# Access Compliance Report

## Public Rights-of-Way

Intersection ID: 10033355	Main Street: OLD_ARDREY_KELL_RD	Cross Street: N/A	Location: SE
ADA ID: 3CEA0666F0F5	Ramp Type: Perp	Initial Pass/Fail: Fail	Overall Compliance: No
Severity Score: 21.25			
Codes/Mitigation Info/Possible Solution		Field Measurements/Component Compliance

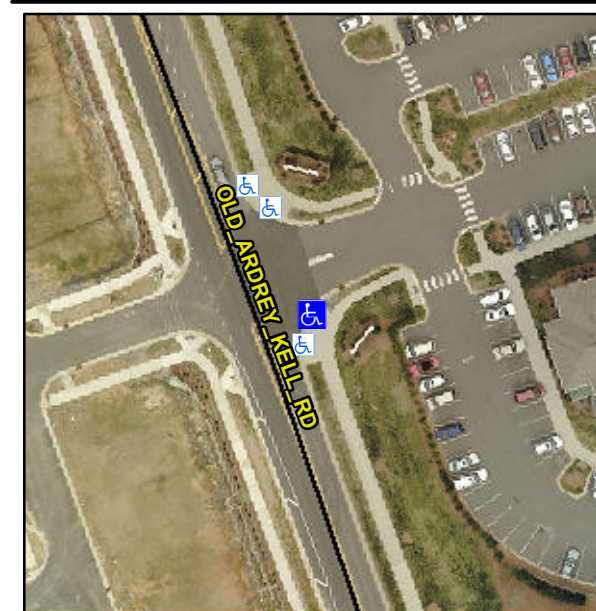
**Not Found, R304.5.1, R304.2.2**

Compliance	Description	Data	Compliance	Description	Data
N/A	Ramp Length (in)	91.0	No	Ramp Slope (%)	8.4
No	Ramp Width (in)	47.5	Yes	Ramp XSlope (%)	1.1
N/A	Flare Type LT	N/A	N/A	Flare Type RT	N/A
N/A	Flare Slope LT (%)	N/A	N/A	Flare Slope RT (%)	N/A
N/A	Flare Traversable LT?	N/A	N/A	Flare Traversable RT?	N/A
N/A	Landing Length (in)	N/A	N/A	DWS Provided?	N/A
N/A	Landing Width (in)	N/A	N/A	DWS Contrast?	N/A
N/A	Landing Slope (%)	N/A	N/A	DWS Length (in)	N/A
N/A	Landing X Slope (%)	N/A	N/A	DWS Full Width?	N/A
N/A	Landing Curb? (Y/N)	N/A	N/A	DWS Offset (in)	N/A
N/A	Shared Landing?	N/A			
N/A	Gutter Ponding?	N/A	N/A	Gutter Slope (%)	N/A
N/A	Gutter Lip Ht (in)	N/A	N/A	Gutter X Slope (%)	N/A
N/A	Painted X Walk1?	No	N/A	Painted X Walk2?	N/A
	X Walk 1 Direction	To N		X Walk 2 Direction	N/A
N/A	X Walk 1 Width (in)	N/A	N/A	X Walk 2 Width (in)	N/A
	X Walk 1 Slope (%)	0.8		X Walk 2 Slope (%)	N/A
	X Walk 1 X Slope (%)	1.7		X Walk 2 X Slope (%)	N/A

**Remove & Replace Entire Ramp.**
